BAR Meeting
February 15, 2017

ISSUE: Permit to Demolish and Certificate of Appropriateness for Alterations

LOCATION: 106 North Lee Street

BAR2017-00020 & 00021

3 WEST ELEVATION — PROPOSED
1/16" = 1'-0"

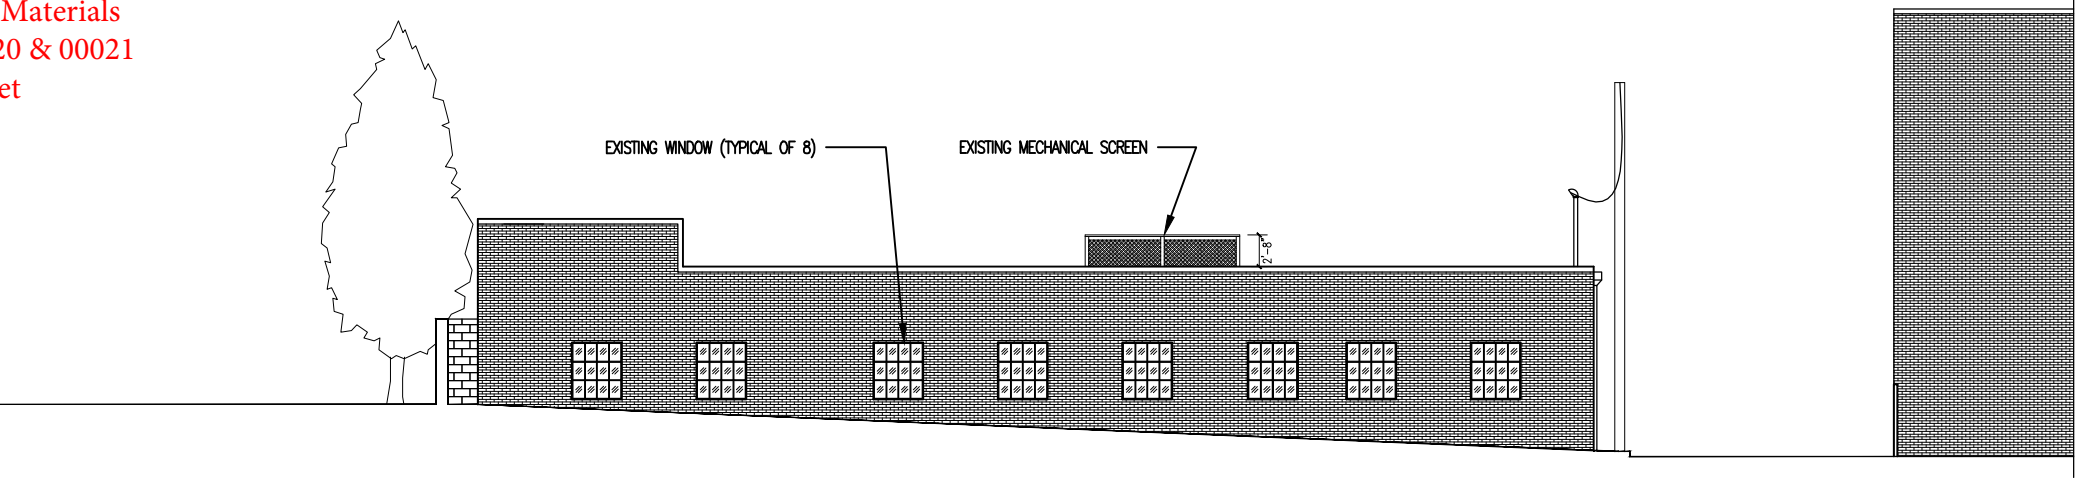
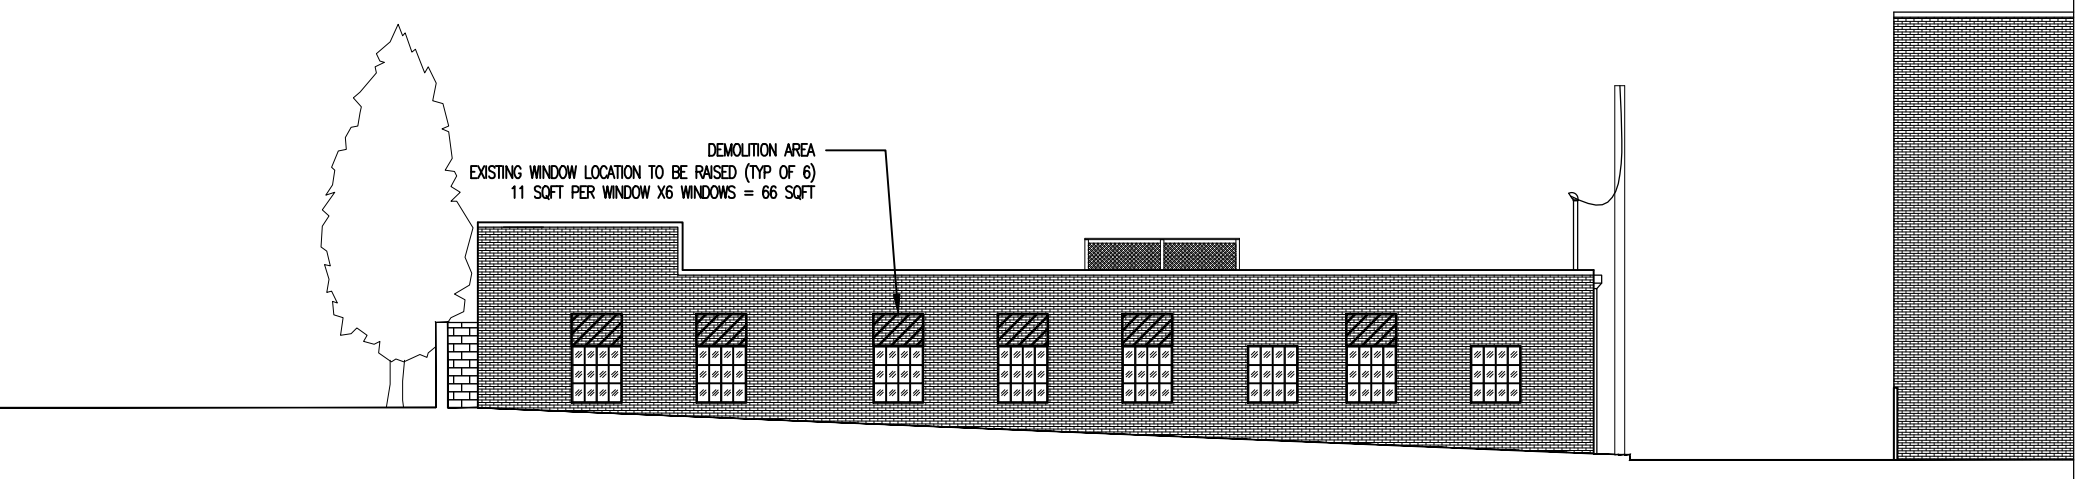
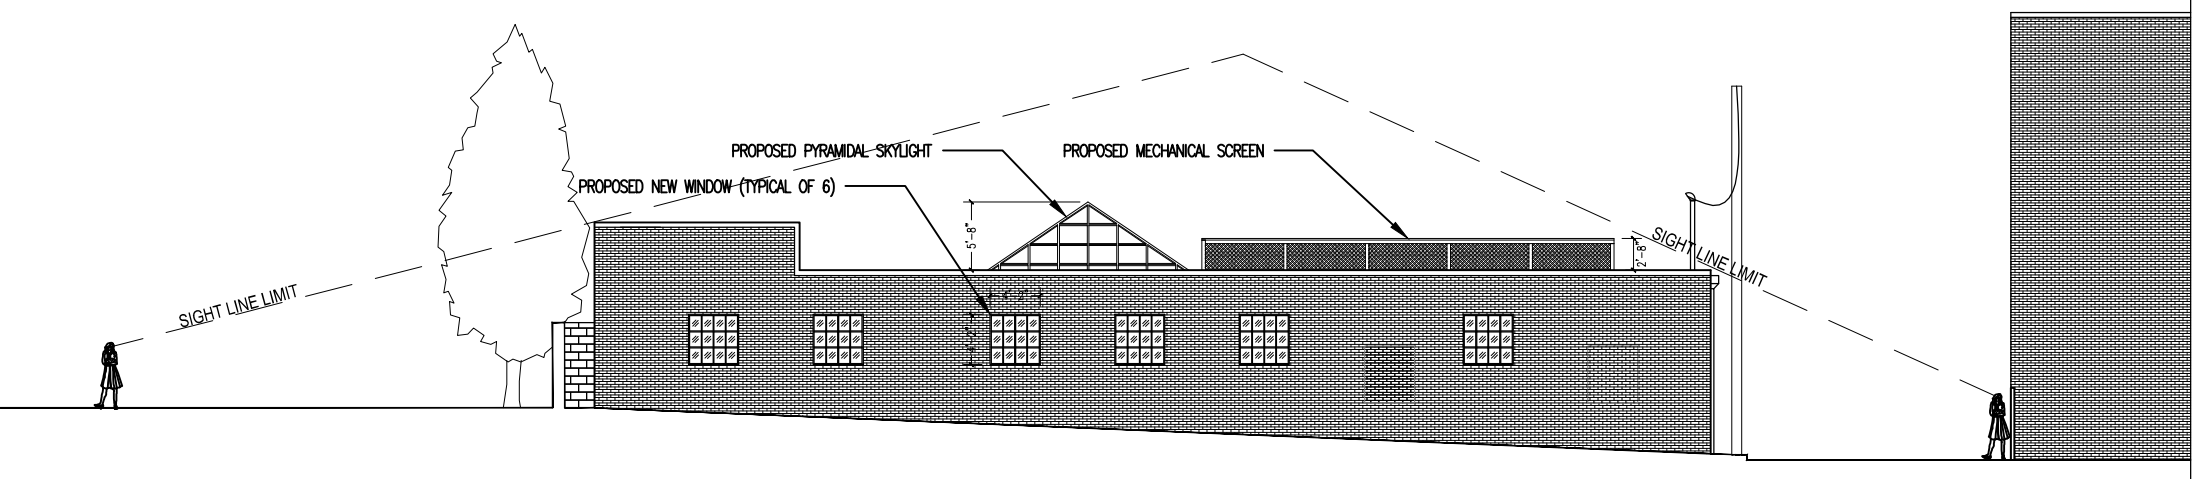
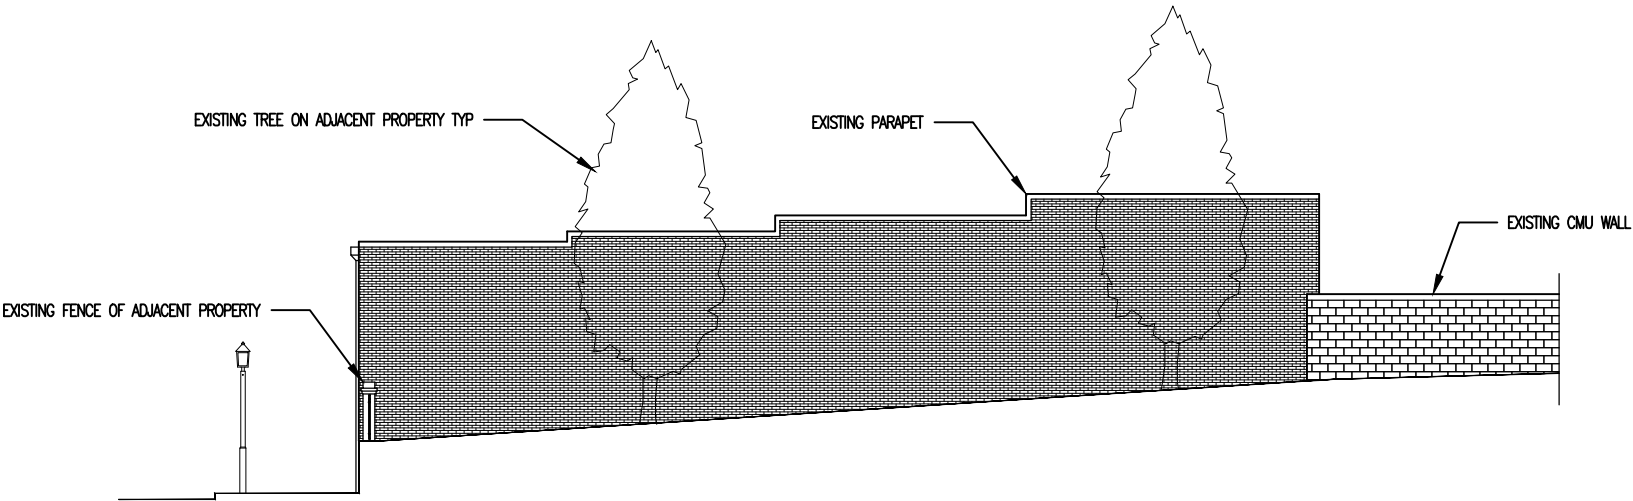
This elevation currently holds eight irregularly-spaced windows centered on the elevation, their sills close to grade. The applicant proposes raising six of the existing eight windows higher up the wall and infilling two windows on the south end. This will entail the demolition of 11 square feet per window (66 square feet total) and the replacement of the current windows with square (4'-2" x 4'-2"), fixed, multi-light windows similar in style to those employed on the façade. The applicant must find bricks that match in color, texture, and size to those that compose the building in order to properly fill in the bottoms of the enlarged/relocated apertures. The applicant must seek final approval of the bricks by BAR staff in the field.

4. The applicant must submit specifications for the new and replacement HVAC units in order to ensure that they comply with the zoning ordinance.
5. Bricks used for infill must match in color, texture, and size those that currently compose the structure, with final approval by staff.
